Hurricane Planning Commission Meeting Agenda

December 8, 2022
5:00 PM

Agenda Date:	12/08/2022
Application Number:	2022-PP-24
Type of Application:	Preliminary Plat Application
Action Type:	Administrative
Applicant:	Western Mortgage and Realty Co
Agent:	Brent Moser
Request:	Approval of a Preliminary Plat
Location:	South of Sand Hollow Road and West of 3700 W
Zoning:	Recreation Resort and RM-3
General Plan Map:	Planned Community

Agenda Date:	12/08/2022
Application Number:	2022-ZC-38 2022-PSP-47
Type of Application:	Zone Change and Preliminary Site Plan Application
Action Type:	Legislative
Applicant:	Shadow Glen 420 Inc
Agent:	Frank Lindhart
Request:	A Zone Change from RM-2 and HC to RM-3 and HC with a PDO
Location:	100 N 2600 W
Zoning:	RM-2 and HC
General Plan Map:	General Commercial and Multifamily

SKY RIDGE PDO
ZONE CHANGE & PRELIMINARY SITE PLAN

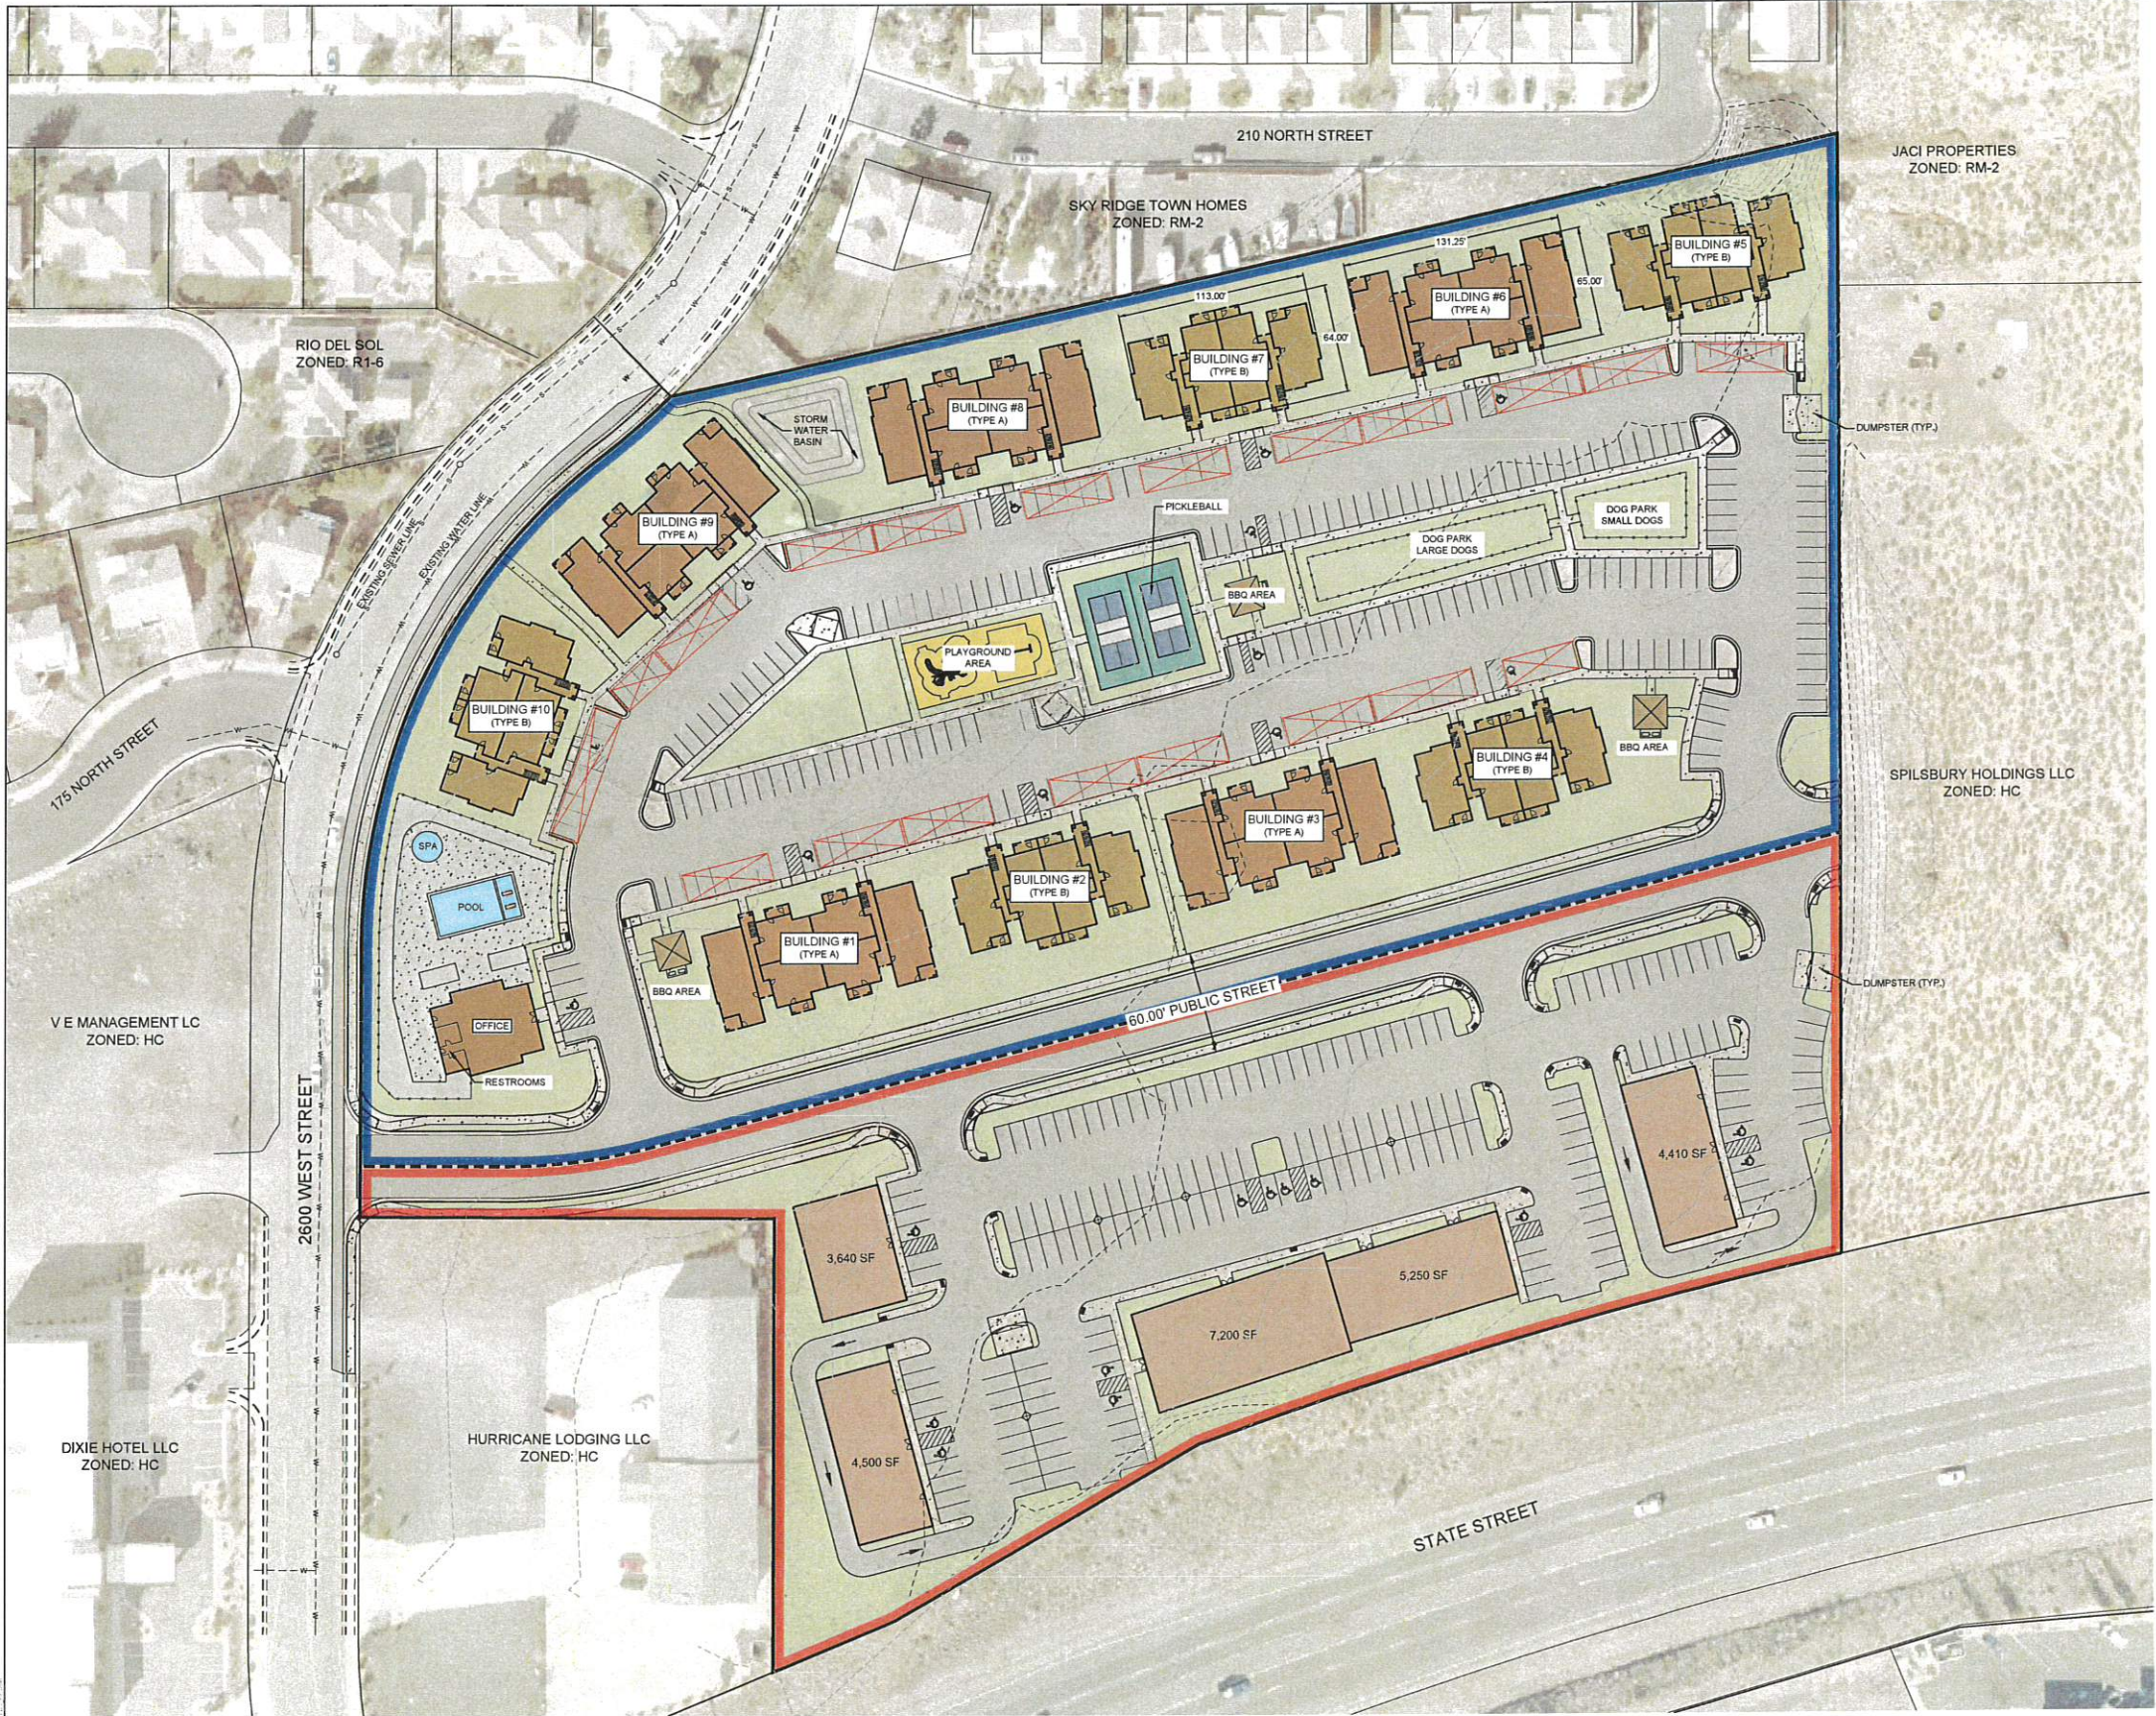
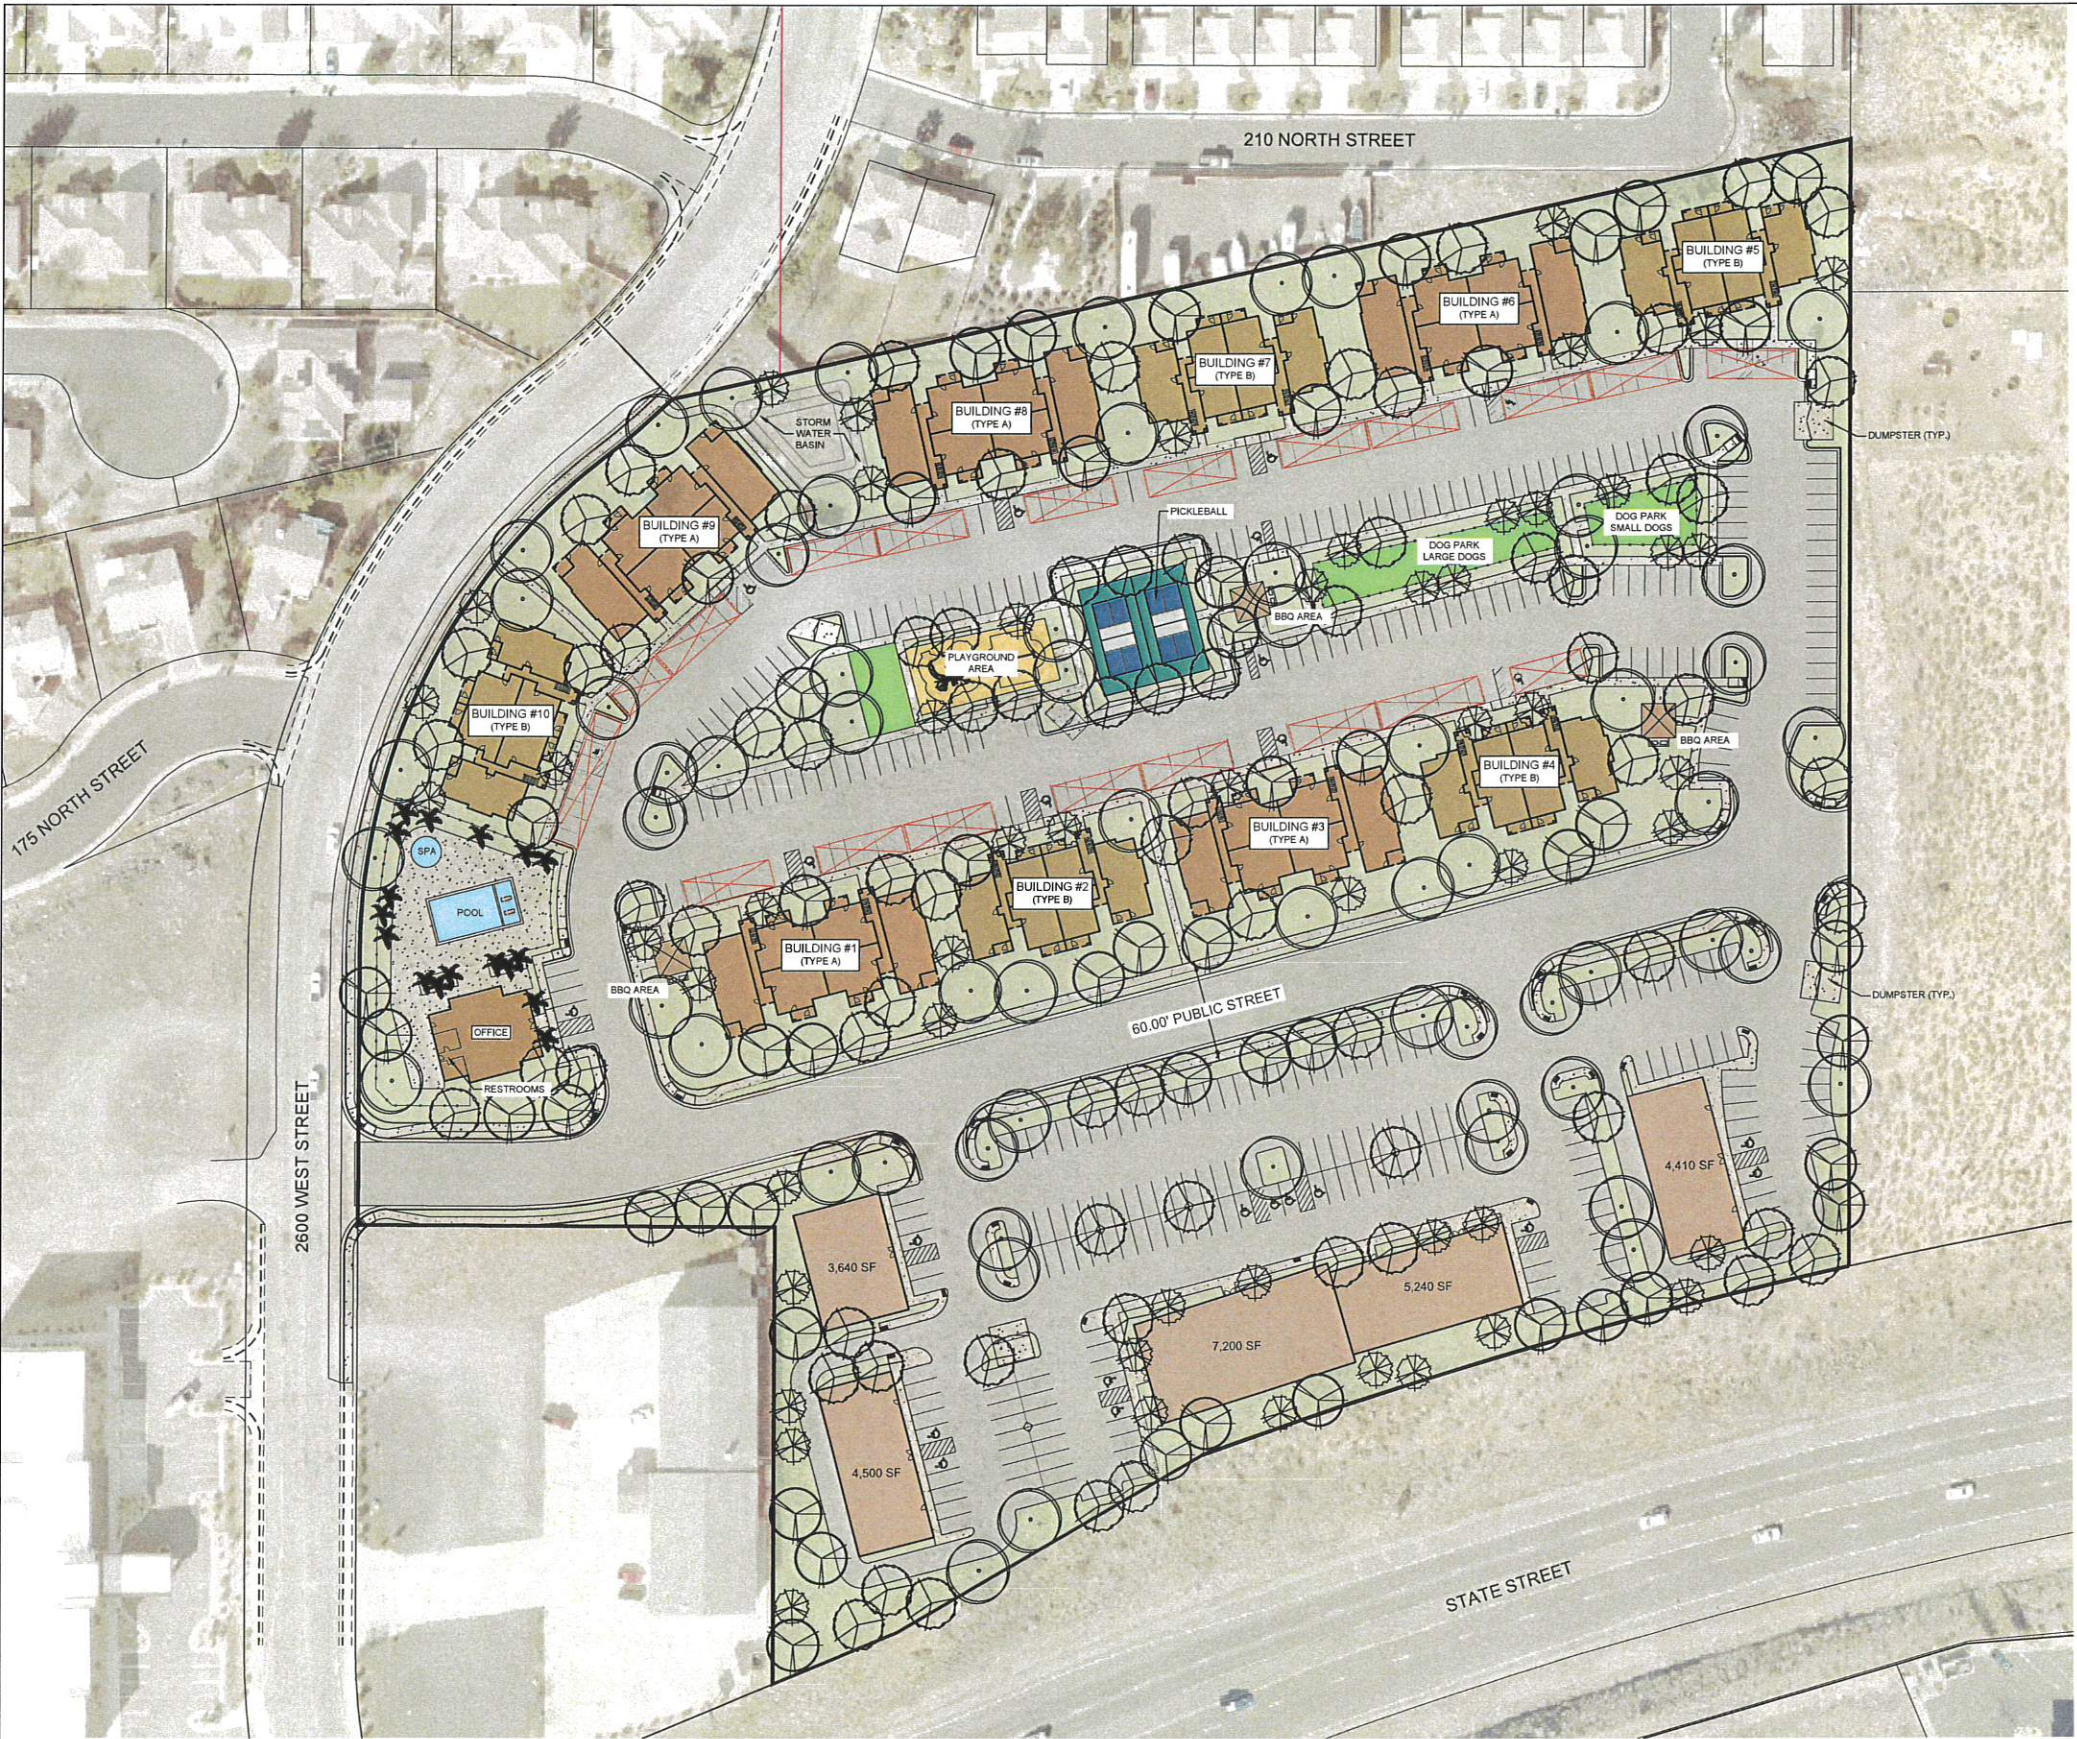
The following items will need to be addressed:

1. **Public Works:** All water lines in the common area will need to be ductile iron. Need to connect to the public street on the east side of the project. Stormwater plan required.
2. **Sewer:** 10’ sewer line main runs north-south through the property. Adjust the building locations or reroute sewer to avoid conflicts.

3. **Water:** Water to the front of the site. Need to see engineering.
4. **Fire:** Need second access. Fire code analysis for buildings depending on number of units

5. **Engineering:** It appears a strip of property along the northernmost property line may be encumbered by a power easement; the power line locations should be located before building locations are approved. It appears a second water main connection is not readily available for water looping. Design may be limited to 650' dead end water main. It appears the project is near a pressure zone boundary. The alignment of the master planned Minor Collector must be discussed by City staff. A 60' ROW is planned to be stubbed to the northeast corner of the property by Desert Fields Phase 2. Master planned roadway is a 67' ROW with a trail on the south side. Curb and gutter and a 12' trail required along State Street. Traffic Impact study required. Throat lengths on driveways must be 50' minimum The water main pressure reducing valve vault and blow off pipe east of it must be planned for. Existing sewer must be located; it appears the existing sewer must be relocated for preferred construction.

6. **Streets:** Assuming all parking areas are private. Check if the stormwater basin is sufficient. Okay with zone change.
7. **Power:** Rocky Mountain power line on the north side of the project. Developer is required to pay for a preliminary assessment for capacity on this circuit. Capacity may not be available for this project. Must fill out construction application from power department and meet together

- a. Judging by the layout on the site plan, these will be two story apartment/condominium units
 - b. The applicant could achieve an identical project with an RM-2 PDO counting the commercial areas toward the residential density as the City did for Copper Rock, Sand Hollow Mesa, and Desert Sands.

2. One of the biggest issues with this layout is the Transportation Master Plan in the area:

5. **Pedestrian Circulation:** The site plan shows a series of paths and sidewalks throughout the development, the site plan also needs to show:
 - a. The master planned trail along 100 N.

- d. The applicant should show cross walks within the parking lot to access the amenity island.

Recommendation: Staff recommends the Planning Commission review this application based on standards with Hurricane City Code. Staff is supportive of the proposed zoning, however there need to be changes to the site plan as laid out above that need to be addressed before staff can recommend approval. Staff has met several times with the adjacent property owners and anticipates that several of the site issues will be resolved prior to the meeting.
